TXX-2912

COMANCHE PEAK STEAM ELECTRIC STATION
TRANSMITTAL OF MATERIAL REQUESTED
BY QUESTION 032.1
FILE NO. 10010

032.0 INSTRUMENTATION AND CONTROL SYSTEMS BRANCH

Q032.1 Provide a listing of the sections of the FSAR which include the responses to the staff positions and questions transmitted to all applicants with RESAR-3 plants. This transmittal was dated November 17, 1977.

FIGURE Q032.1-12

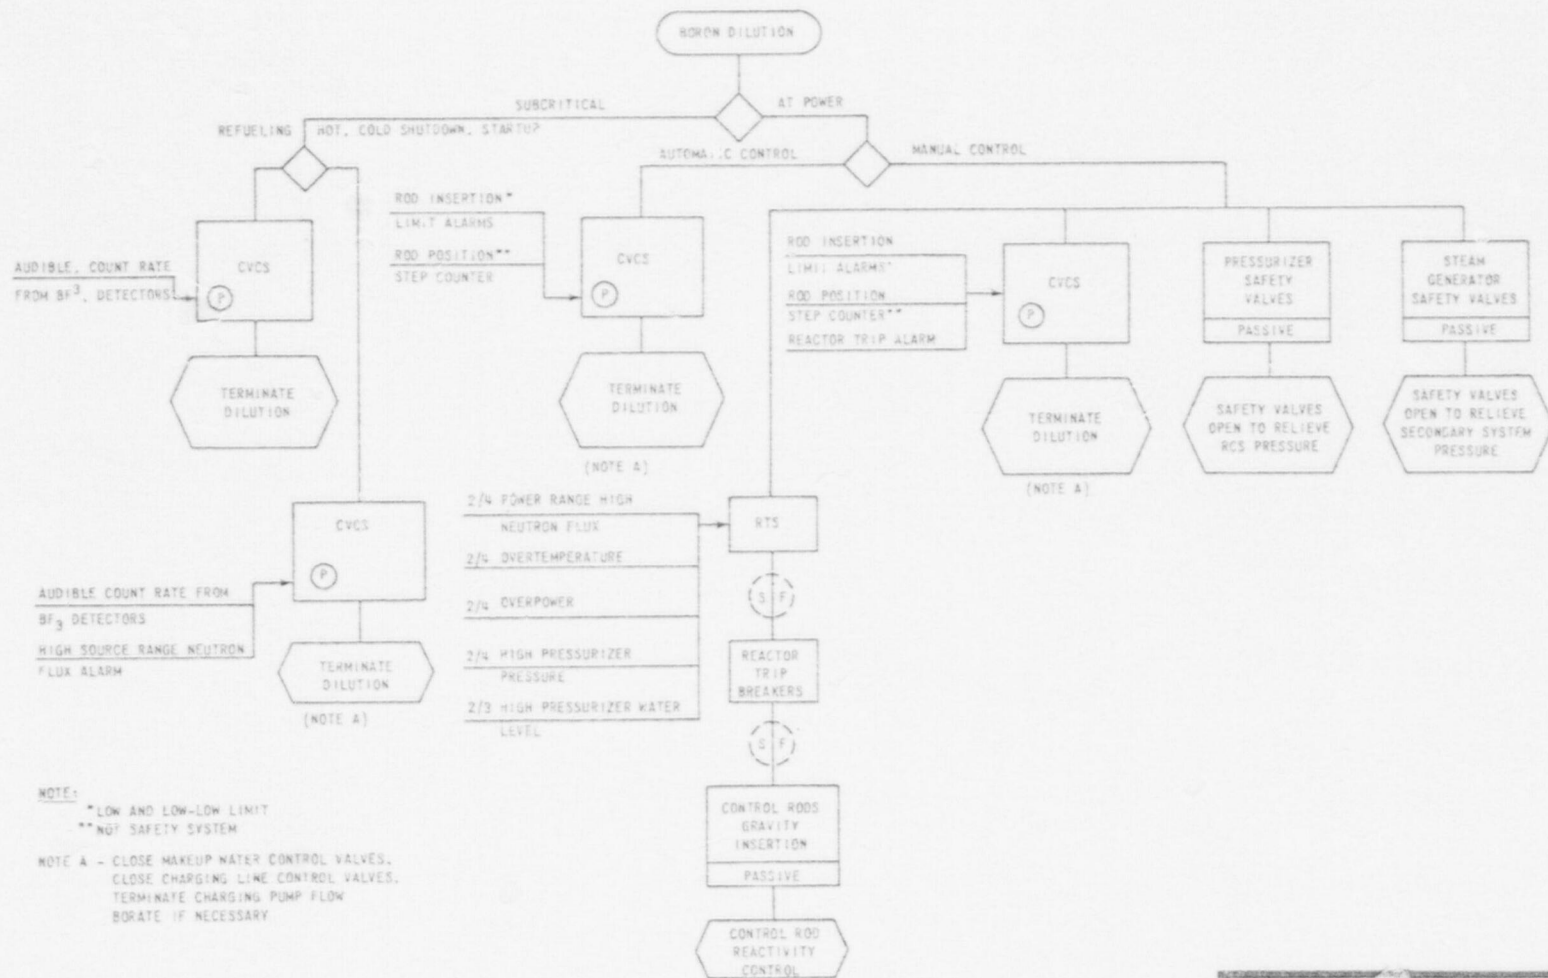
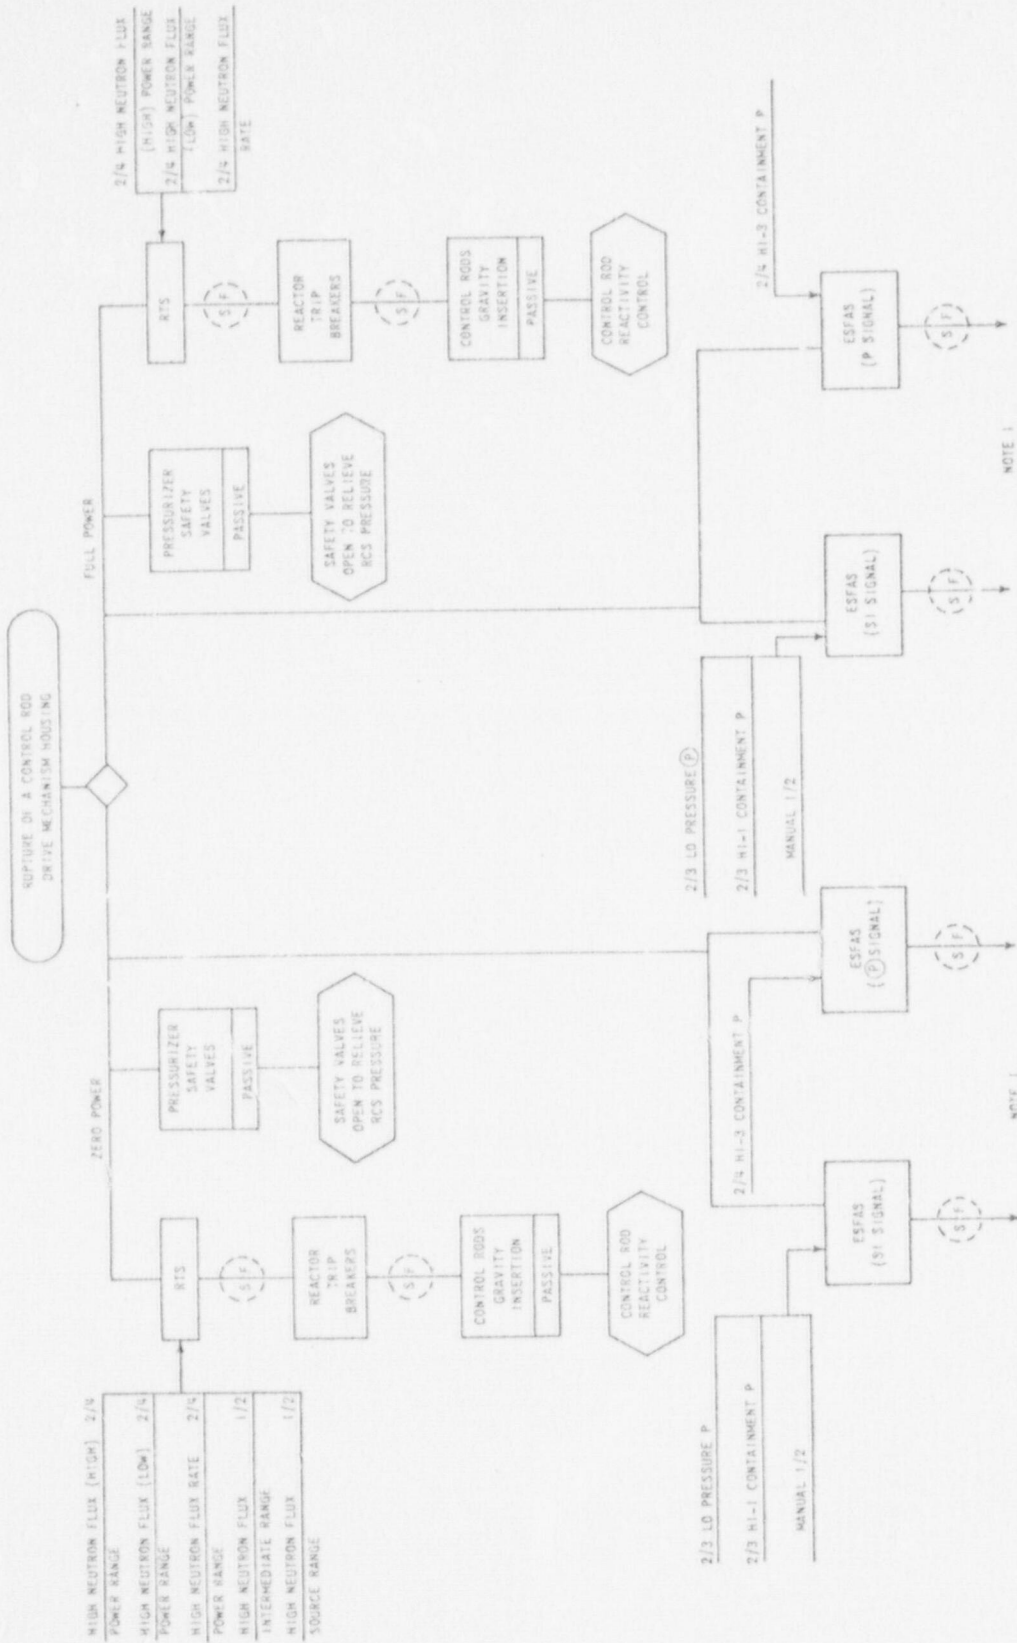
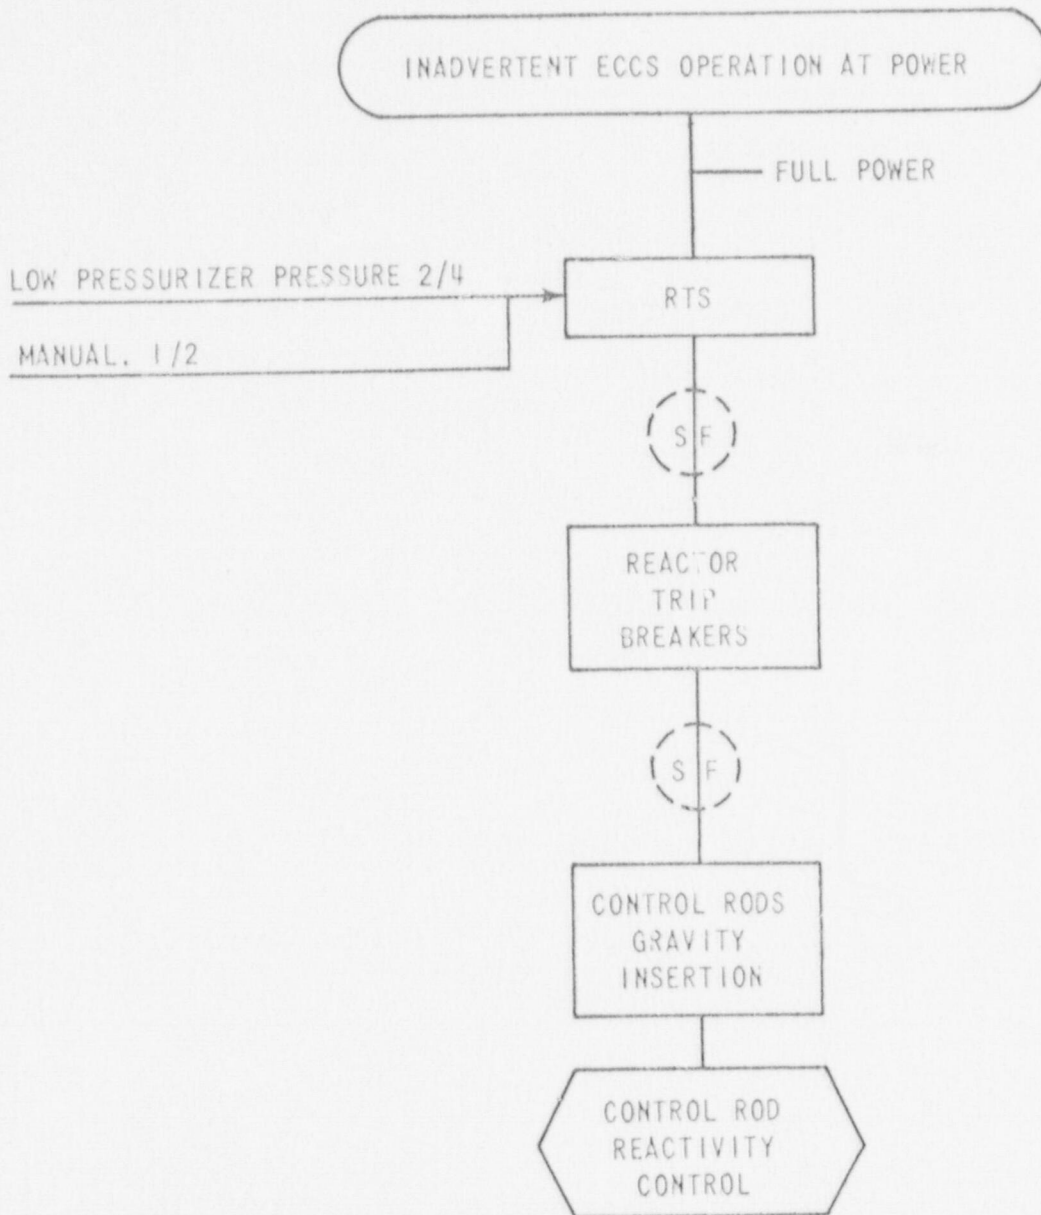
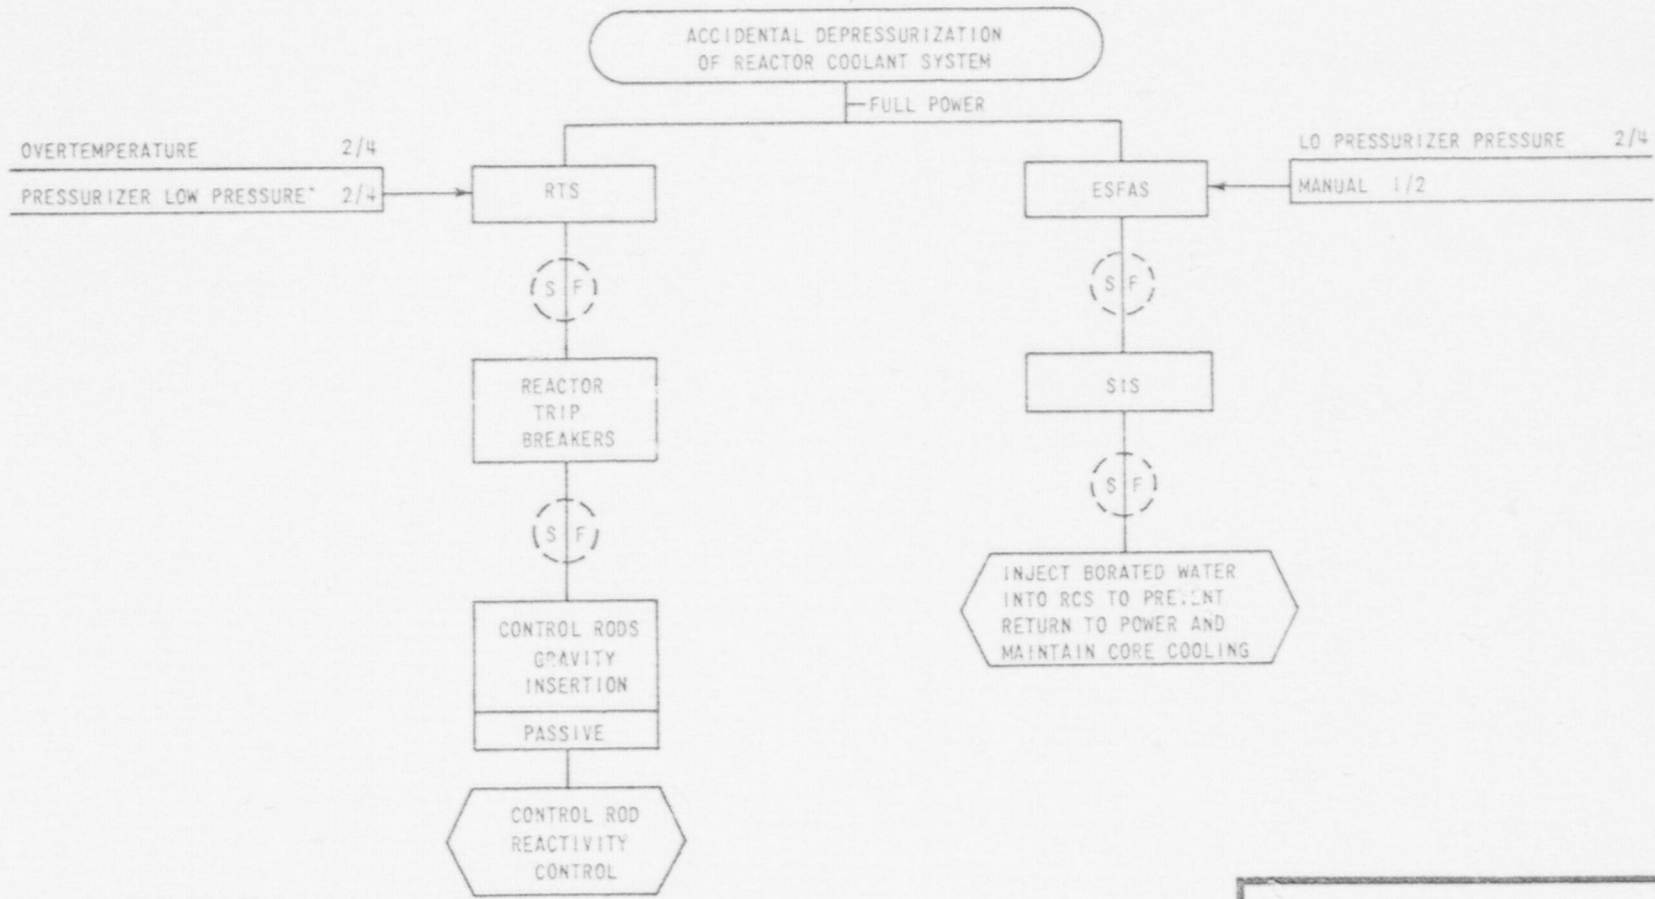
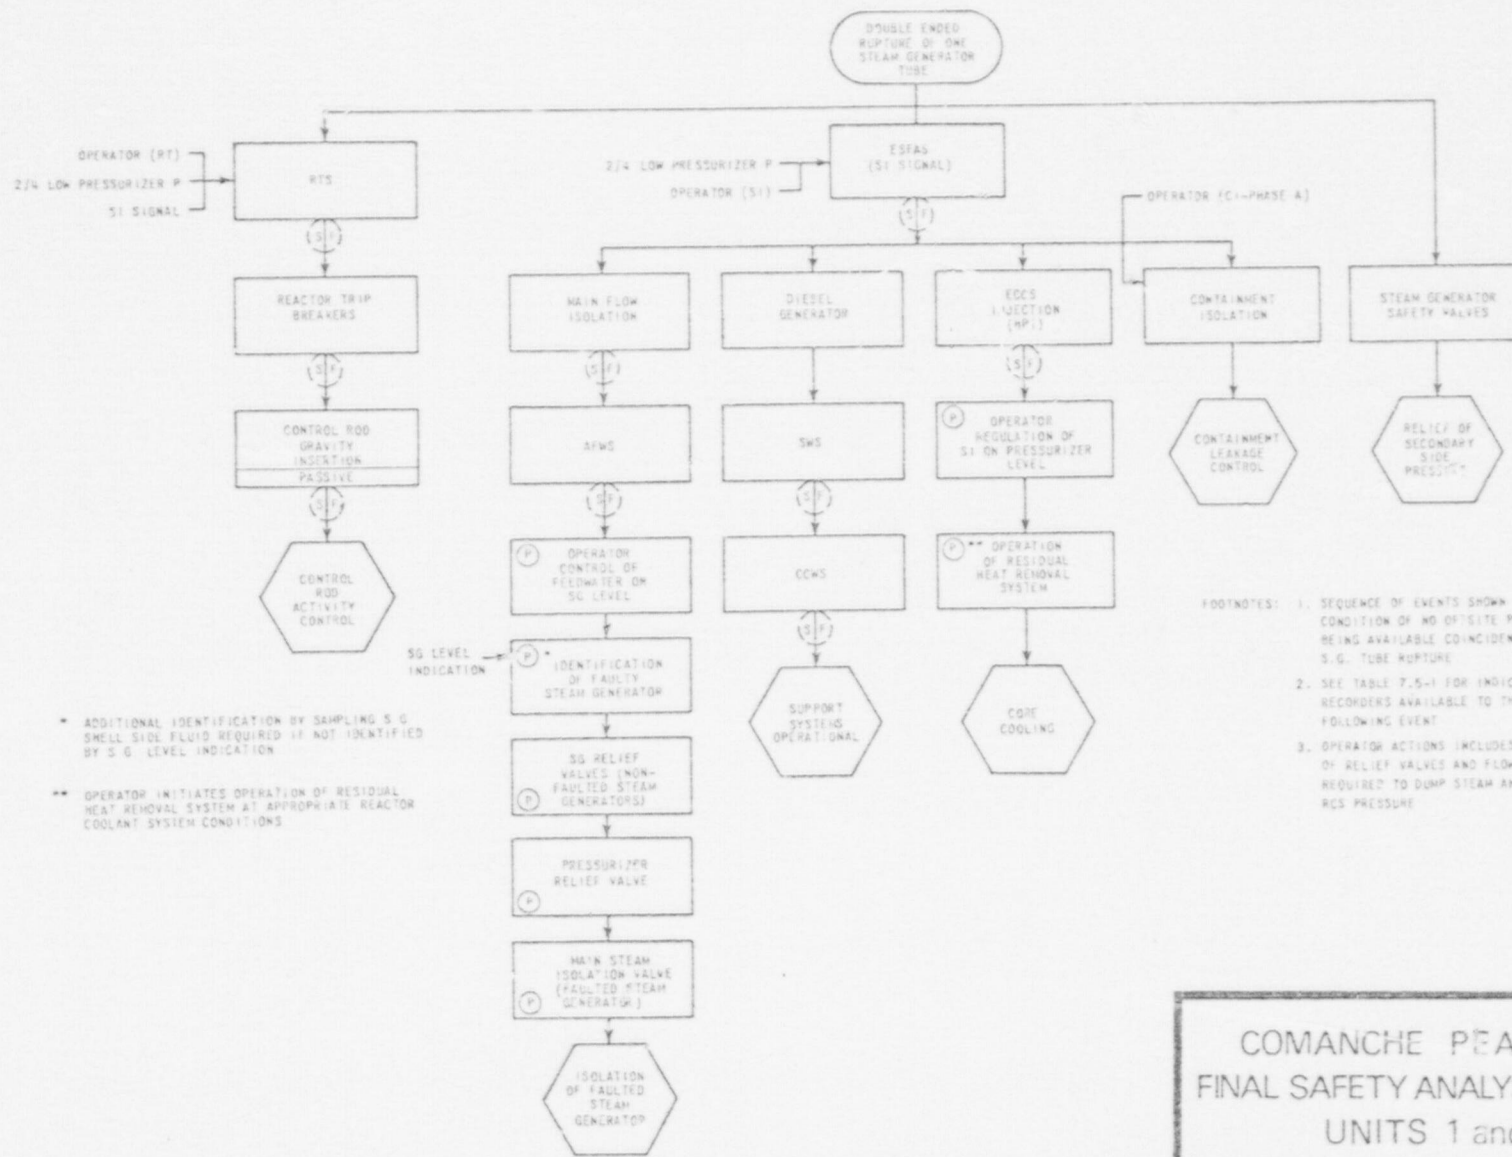
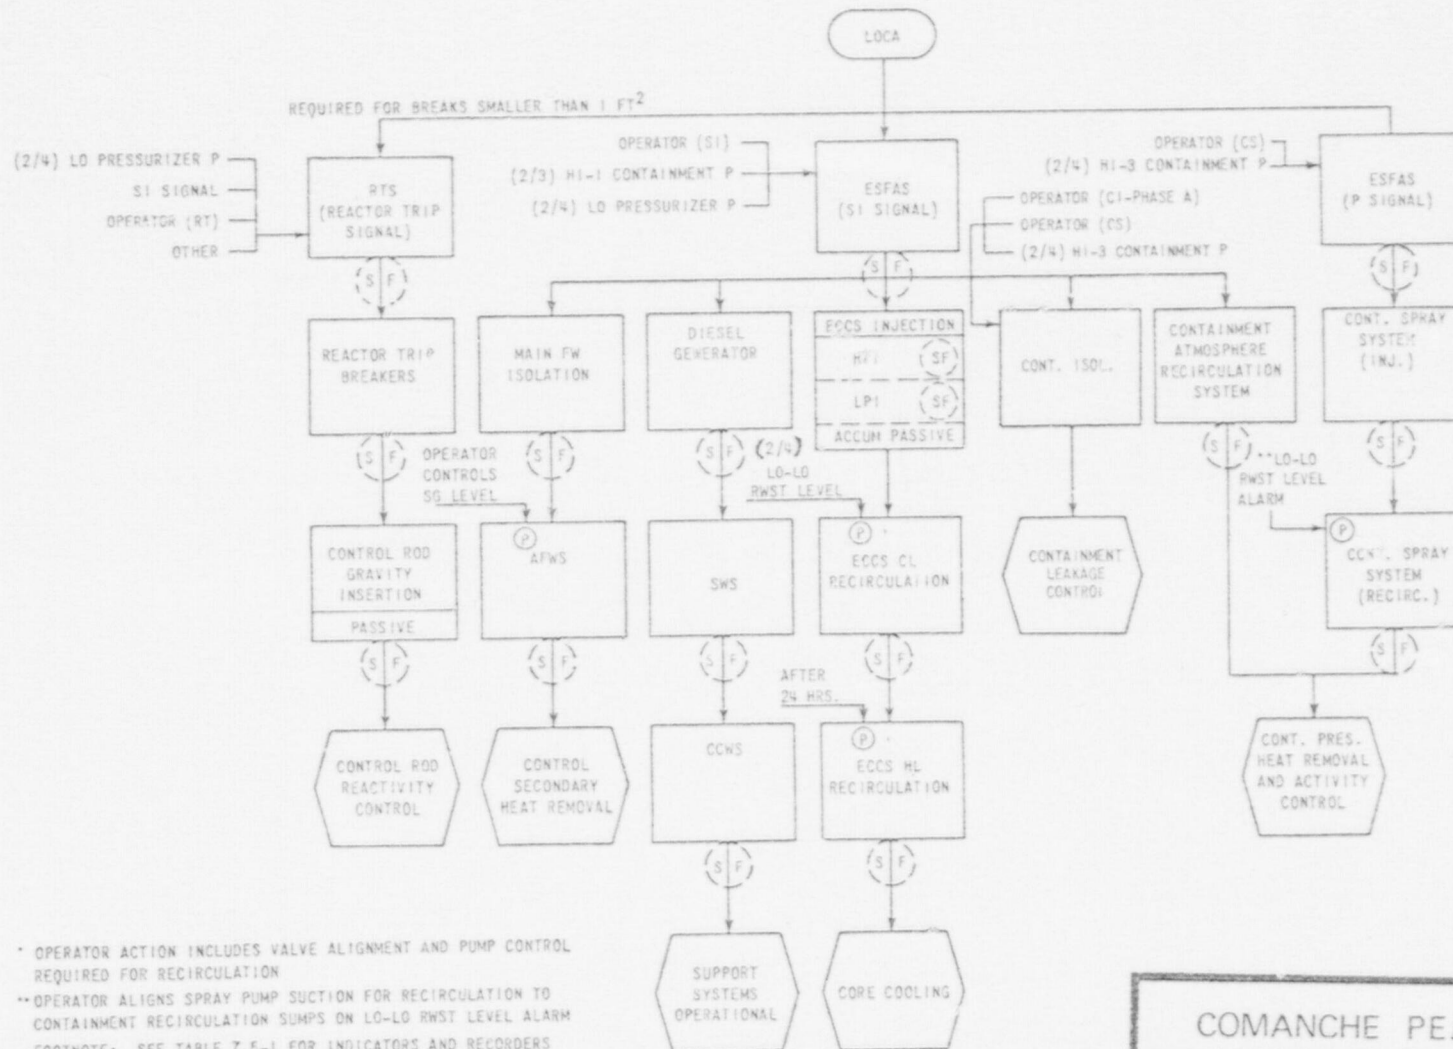
RESAR-3 For each transient and accident analyzed in Chapter 15,
(15.0.1) provide the following information:

- (1) The step-by-step sequence of events from event initiation to the final stabilized condition. This listing should identify each significant occurrence on a time scale, including for example: flux monitor trip, insertion of control rods begin, primary coolant pressure reaches safety valve set point, safety valves open, safety valves close, containment isolation signal initiated, containment isolated, etc. All required operator actions should also be identified.
- (2) The extent to which normally operating plant instrumentation and controls are assumed to function.
- (3) The extent to which plant and reactor protection

systems are required to function.

- (4) The credit taken for the functioning of normally operating plant systems.
- (5) The operation of engineered safety systems that is required.

Response These diagrams are given in Figures Q032.1-1 to Q032.1-24.
